C104
COMMUNICATION
COUNCIL – October 20, 2021
CW (2)- Report No. 46, Item 9

**VAUGHAN COMPREHENSIVE ZONING BY-LAW - FINAL DRAFT - 2748355 CANADA INC.,
MOBILIO DEVELOPMENTS LTD., RP B3S HOLDINGS INC. AND RP B3N HOLDINGS INC.
COMMENTS**

COMPREHENSIVE ZONING BY-LAW REVIEW - 2748355 CANADA INC. COMMENTS

**COMPREHENSIVE ZONING BY-LAW - SECOND DRAFT - 2748355 CANADA INC.
COMMENTS**

Figure 1. Landmark Locations from Schedule A2 of Zoning By-law 1-88

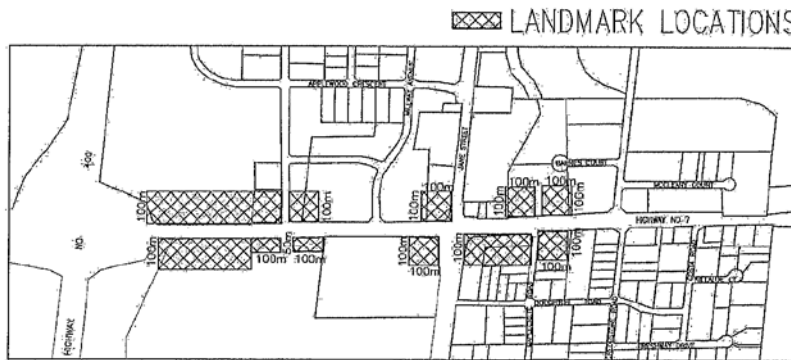
IBI Group would also like to highlight that notable provisions from Zoning By-law 1-88 are missing from the current Draft Comprehensive Zoning By-law, including the Landmark Location provision from Schedule A2 of Zoning By-law 1-88 (**Figure 1**). This provision permits unlimited height in certain locations along Highway 7 to serve as a gateway to the Highway 7 corridor. IBI Group is not supportive of the exclusion of these provisions from the Comprehensive Zoning By-law and wish to see them included in the Second Draft. Several towers have already been approved and/or constructed along Highway 7 within the Landmark Locations, setting a precedent for the built-form along this corridor. The removal of these provisions will create a disconnect between the built-form, conflicting with several of the City’s Urban Design objectives and creating great variations in height and density.

Figure 1. Landmark Locations from Schedule A2 of Zoning By-law 1-88

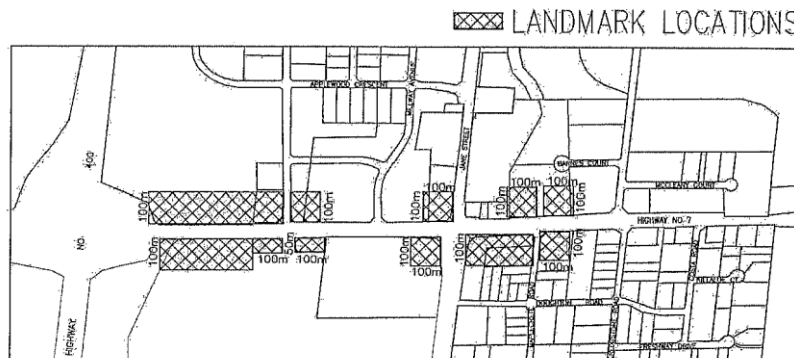
IBI Group would also like to highlight that notable provisions from Zoning By-law 1-88 are still missing from the Second Draft Comprehensive Zoning By-law, including the Landmark Location provision from Schedule A2 of Zoning By-law 1-88 (**Figure 1**). This provision permits unlimited height in certain locations along Highway 7 to serve as a gateway to the Highway 7 corridor. IBI Group is not supportive of the exclusion of these provisions from the Comprehensive Zoning By-law that essentially downzone the parcels and wish to see them included in the Final Draft. The removal of these provisions will create a downzoning that is inconsistent with provincial policy related to urban growth centres and MTSAs.
